Product Change Notification / MFOL-05LHKQ810

CCB 5253 Final Notice: Qualification of MTAI as an additional final test site for MIC5219-5.0YMT-TR and MIC5219YMT-TR catalog part numbers (CPN) available in 6L UDFN (2x2x0.6mm) package.

CCB 5253
Pre and Post Change Summary
PCN #: MFOL-05LHKQ810

Pre and Post Change Summary - Carrier Tape

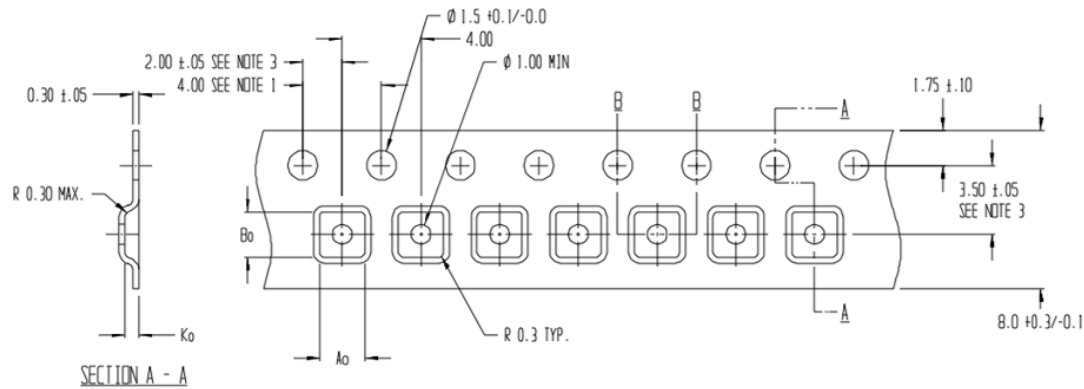
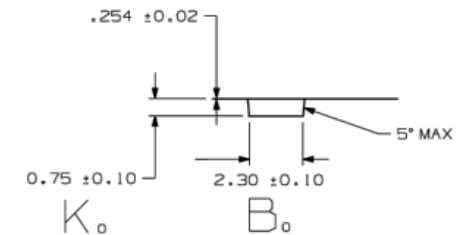
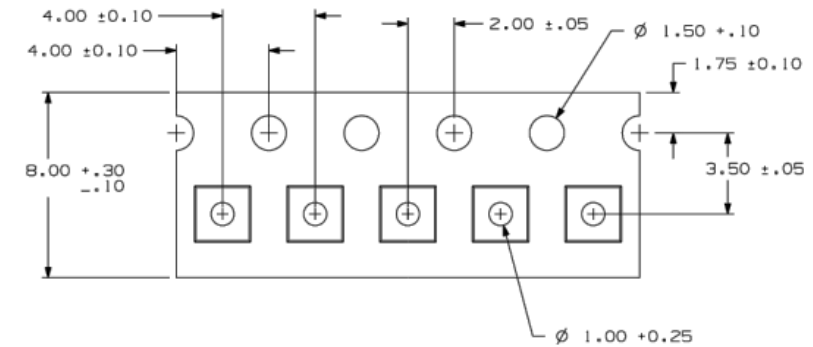
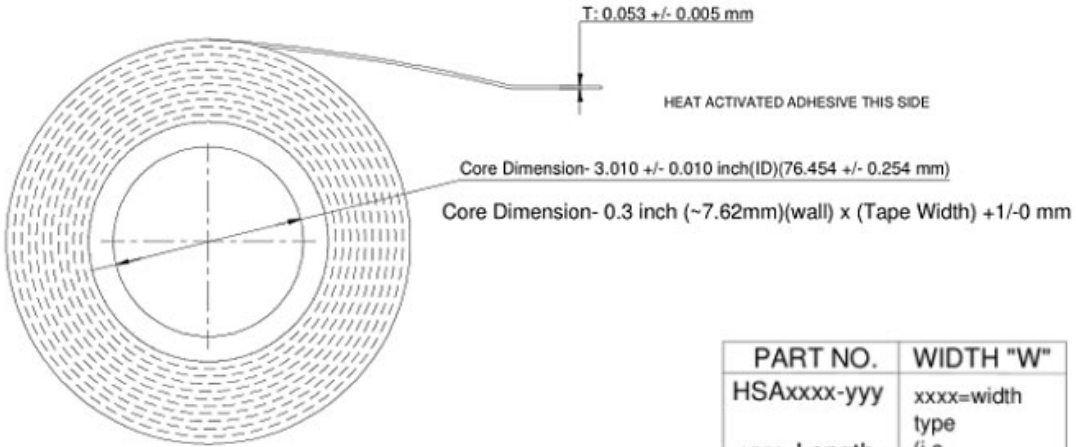
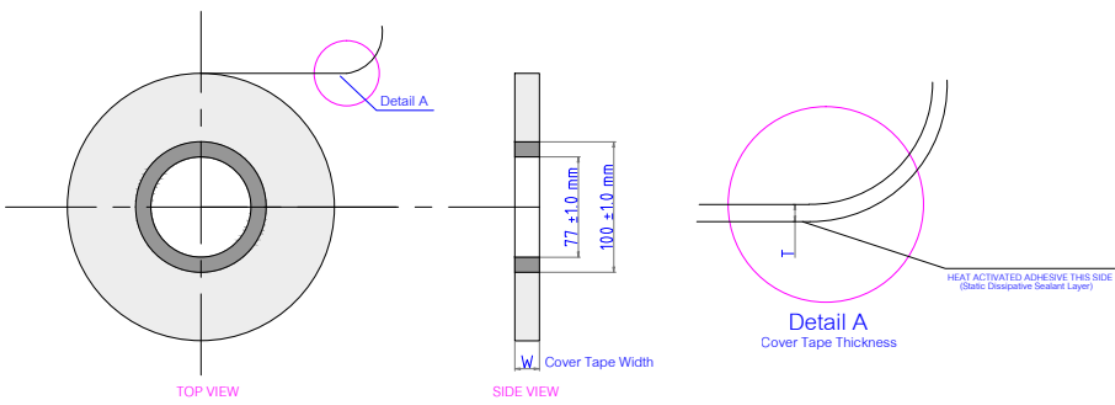
Plant	W (mm.) ± 0.3 or Specific	P (mm.) ± 0.1 or Specific	A ₀ ± 0.1 or Specific	B ₀ ± 0.1 or Specific	K ₀ ± 0.1 or Specific
UNIC	8.00+03/-0.1	4.00mm	2.30mm	2.30mm	0.70mm
MTAI	8.00+0.3/-0.1	4.00mm	2.30mm	2.30mm	0.75mm

Pre and Post Change Summary - Plastic Reel

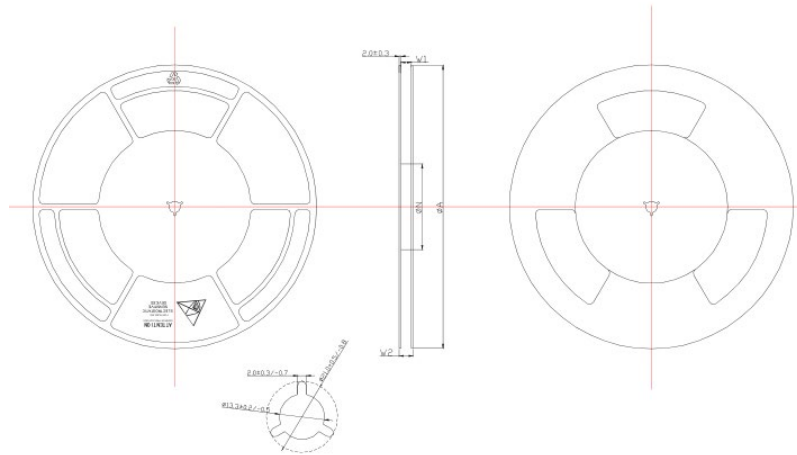
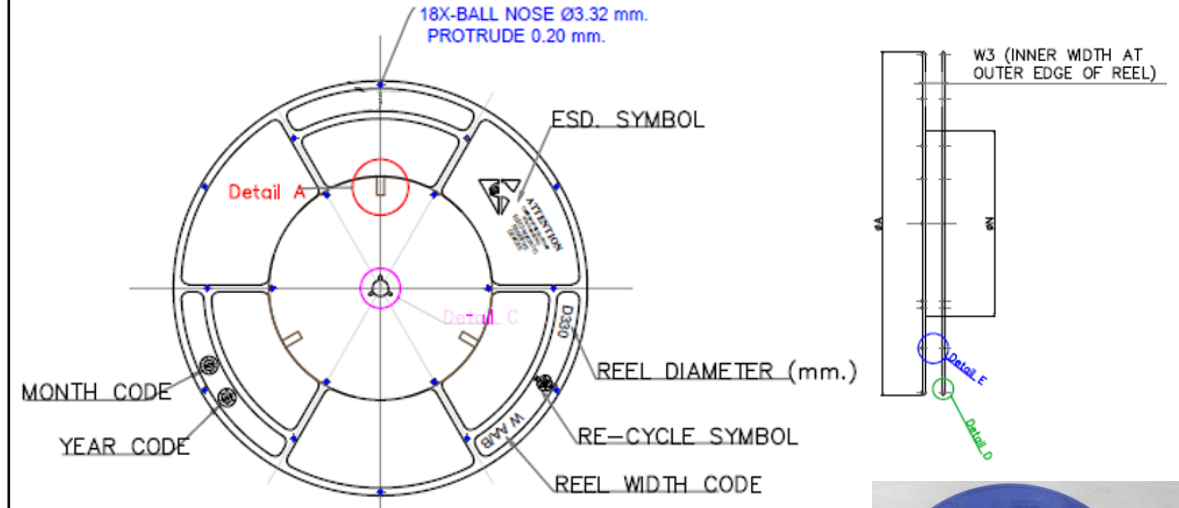
Plant	Reel diameter	Reel Hub Size (mm)	Reel Width Max (mm)	Reel Color
UNIC	330 +/- 2.0	178 +/- 1.0	15.4	White
MTAI	330 +/- 2.0	178 +0/- 2.0	14.40	Dark Blue

Pre and Post Change Summary – Static Shielding Bag

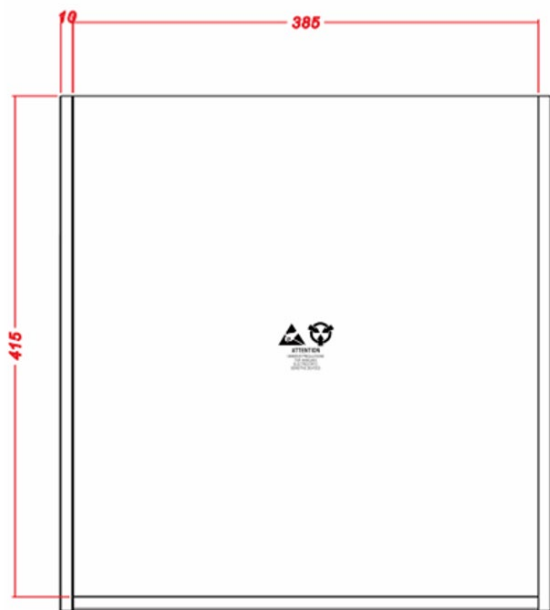
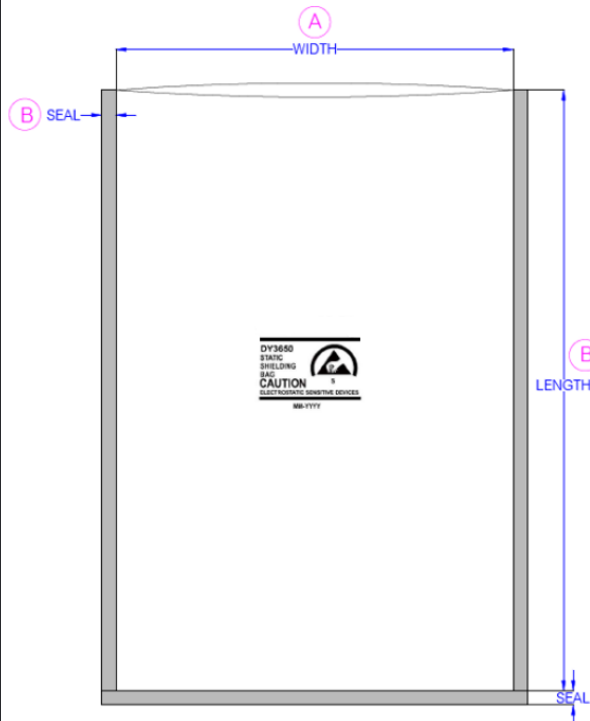
Plant	Length (mm)	Width (mm)	Thickness (mm)
UNIC	415	385	0.08
MTAI	420	370	0.076
